BEFORE THE
PUBLIC SERVICE COMMISSION OF WISCONSIN

In the Matter of Proposed Revision of Wis. Admin. Code ch. PSC 114
as Wisconsin State Electrical Code, Volume 1

ORDER ADOPTING FINAL RULES

The Public Service Commission of Wisconsin proposes an order to repeal and recreate ch. PSC 114, Wis. Admin. Code relating to rules concerning electric safety—Revision of Volume 1 of the Wisconsin State Electrical Code.

Figure PSC 114-317B1.

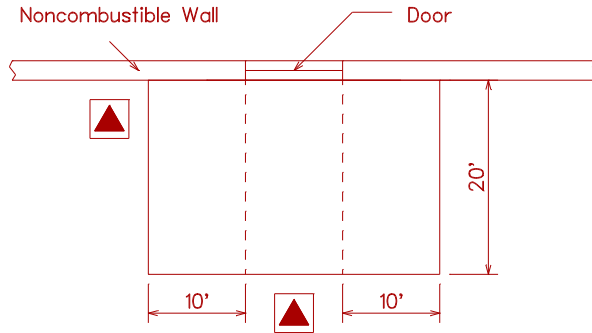
1. Padmounted oil-insulated transformers shall not be located within a zone extending 6.1 m (20 ft) outward and 3.0 m (10 ft) to either side of a building door. See Figure PSC 114-317B1.

Figure PSC 114-317B2.

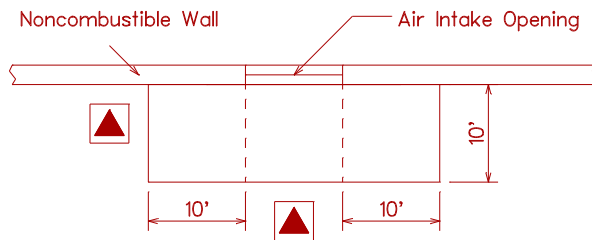
2. Padmounted oil-insulated transformers shall not be located within a zone extending 3.0 m (10 ft) outward and 3.0 m (10 ft) to either side of an air intake opening. Such transformers may be located within said zone beneath an air intake opening provided there is not less than 7.6 m (25 ft) diagonal separation between the transformer and said opening. See Figure PSC 114-317B2.

Figure PSC 114-317B3a.

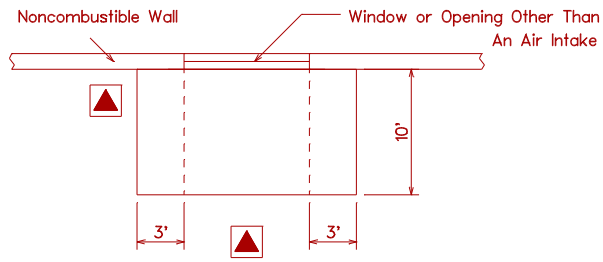
3.a. Padmounted oil-insulated transformers shall not be located within a zone extending 3.0 m (10 ft) outward and 0.9 m (3 ft) to either side of a building window or opening other than an air intake. See Figure PSC 114-317B3a.

Exception: This does not apply to a glass block or fire window meeting the requirements of the Wisconsin Commercial Building Code (Fire Window IBC Chapter 7, Section 714.3).

Figure PSC 114-317 B3b.

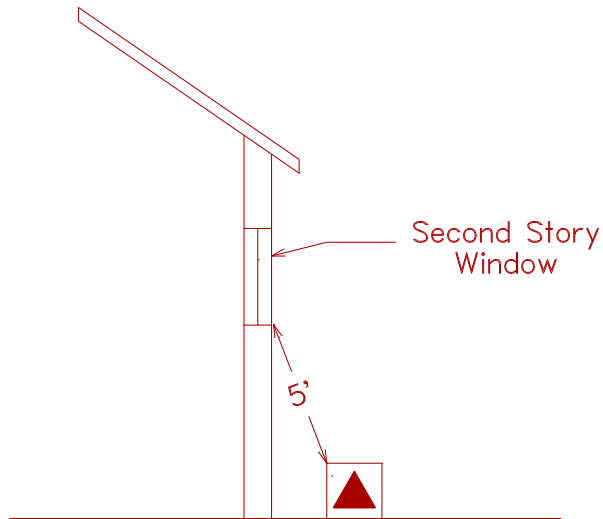
3.b. For second story windows, the transformer shall not be located less than 1.5 m (5 ft) from any part of the window. See Figure PSC 317B3b.

Exception: This does not apply to a glass block or fire window meeting the requirements of the Wisconsin Commercial Building Code (Fire Window, IBC Chapter 7, Section 714.3).

Figure PSC 114-317D1.

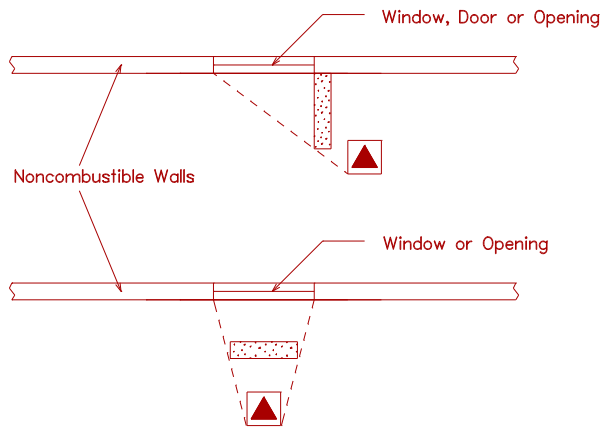
The barrier shall extend to a projection line from the corner of the padmounted transformer to the furthest corner of the window, door or opening in question. The height of the barrier shall be 0.3 m (1 ft) above the top of the padmounted transformer. See Figure PSC 114-317D1.

Figure PSC 114-317D2.

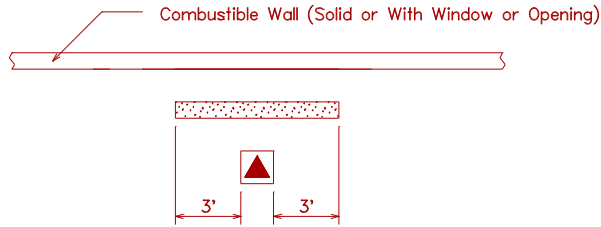
The barrier shall extend 0.9 m (3 ft) beyond each side of the padmounted transformer. The height of the barrier shall be 0.3 m (1 ft) above the top of the transformer. See Figure PSC 114-317D2.

Figure PSC 114-317E1

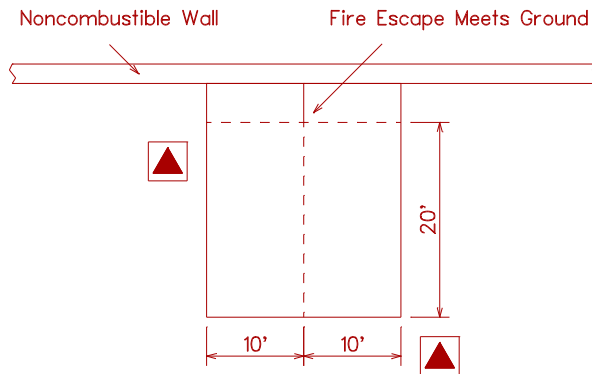
1. Padmounted oil-insulated transformers shall not be located within a zone extending 6.1 m (20 ft) outward and 3 m (10 ft) to either side of the point where a fire escape meets the ground. See Figure PSC 114-317E1.

Figure PSC 114-317E2

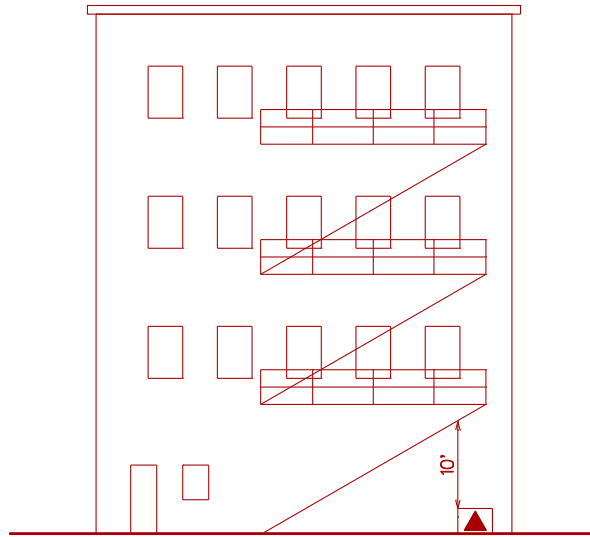
2. Padmounted oil-insulated transformers located beneath fire escapes shall have a vertical clearance of not less than 3 m (10 ft) from the top of the transformer to the bottom of the fire escape. See Figure PSC 114-317E2.
